Development and Resource Management Department

July 6, 2016

**SUBJECT: DEVELOPMENT PERMIT APPLICATION NO. D-16-031 FOR PROPERTY
LOCATED AT 1161 EAST SHEPHERD AVENUE (APN: 403-021-03)**

Development Permit Application No. D-16-031, which proposes a 34-unit, gated multiple family residential development with amenities such as enhanced architectural features, open courtyards, extensive landscaping in buffer zones adjacent to single-family residences, carports, and a block wall along shared property lines with adjacent properties on approximately ±2.27 acres of property on the south side of East Shepherd Avenue between North Millbrook and North Cedar Avenues.

ARCHITECTURAL SITE
PLAN

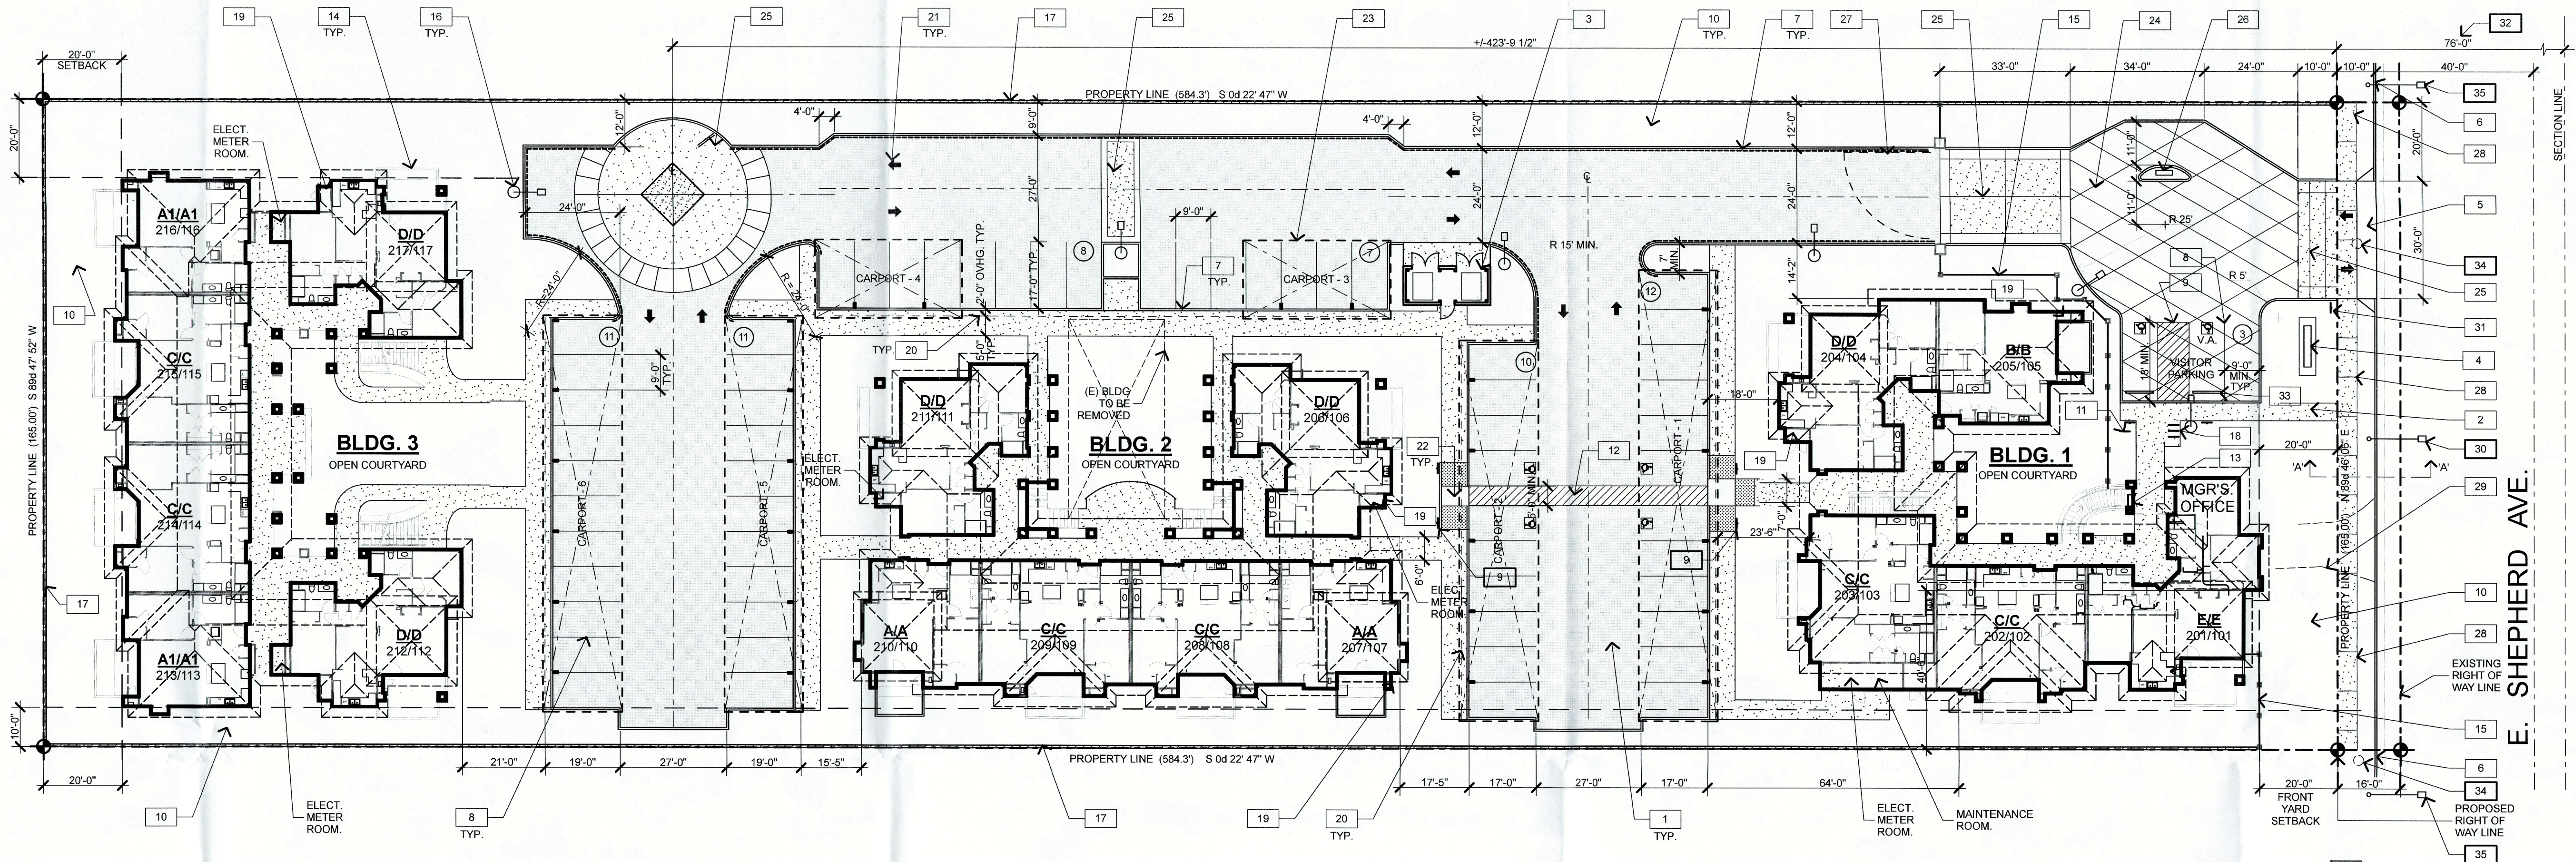
Planner to check when completed	
<input type="checkbox"/>	1. Transfer all red line notes, etc., shown on Exhibits A dated May 20, 2016 and Exhibits B-1, B-2, E-1, E-2, E-3, E-4, E-5, R-1, R-2, R-3, F-1, F-2, F-3, F-4, F-5, F-6, F-7, F-8, and L dated April 5, 2016, to corrected exhibits. Submit the corrected exhibits for further review and approval. Please also review other agency/departments comments and revise site plan accordingly. Transfer all comments and conditions on exhibits to the

Required	Table, §15-1003 for RM-1 District: Frontage Coverage = minimum 50% of area between the minimum and maximum front setback area. Lot Coverage = maximum 50% of lot. On-site Open Space = minimum 20% of lot area.
Proposed	Lot coverage of 35.4%, as shown in site plan notes. <i>As a condition of project approval - Provide frontage coverage calculation and illustrate on Site Plan.</i>

Comment	<p>Show typical dimensions of parking stalls on the Site Plan that conform to City Standards – provided.</p> <p>As a condition of project approval – Show 10 additional uncovered parking stalls on the Site Plan (may convert the additional covered stalls shown on site Plan).</p>
ON-SITE OPEN SPACE
